SITE & BUILDING CONSTRUCTION EVALUATION

Section 1 Site Access

Curb ramp & access aisle (#0941 at front)

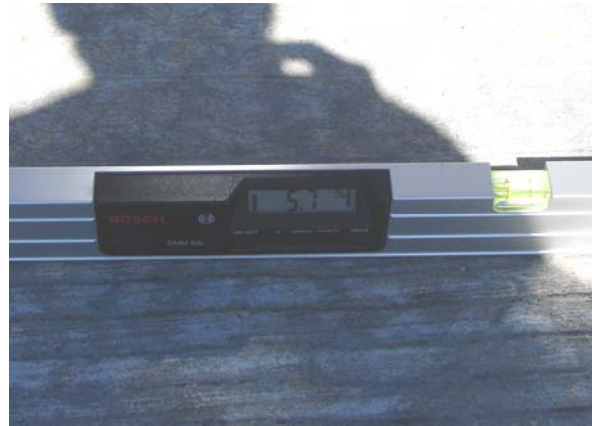
The only curb free access from the street and parking lot to the leasing office entrance and to the rent drop slot required use of the curb ramp located adjacent to the parking area in front. This curb ramp connected directly to the vehicular lane.

From the curb ramp, there was no accessible route to the front entry provided. The landing where the sidewalk turns 90 degrees had a cross slope of 5.0% in one direction (2% maximum allowable), the sidewalk had cross slopes up to 4.4% (2.0% maximum allowable) and the curb ramp had a cross slope of 5.7% (2.0% maximum allowable) and the curb ramp lacked required detectable warnings (ANSI 4.7.2, 4.8.2 and 4.27).

All curb ramps on site must comply with the requirements of ANSI 4.7 Curb Ramps and 4.27 Detectable Warnings.

Pet Post (#9672)

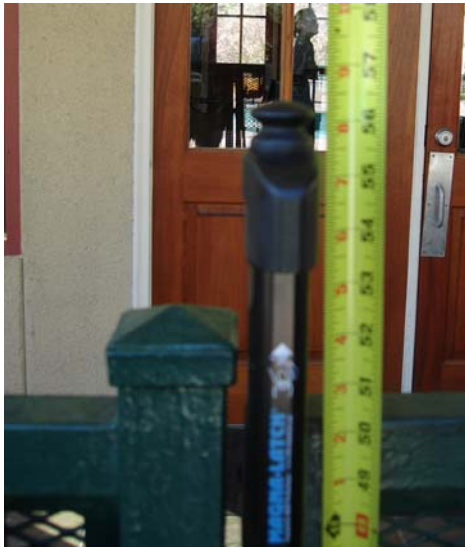
No accessible routes were provided to dog owner trash and bag dispenser poles.

Gate at Game Room (#0877)

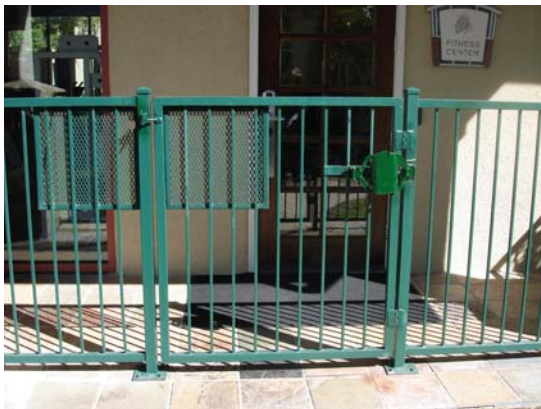
The gate to the game room had a pull up latch with the operable parts mounted above the 48 inches permitted for forward reach range (55-3/4 inches measured) (ANSI 4.2.5). A forward reach would be required in order to approach the gate, operate the hardware and then pass through to the other side.
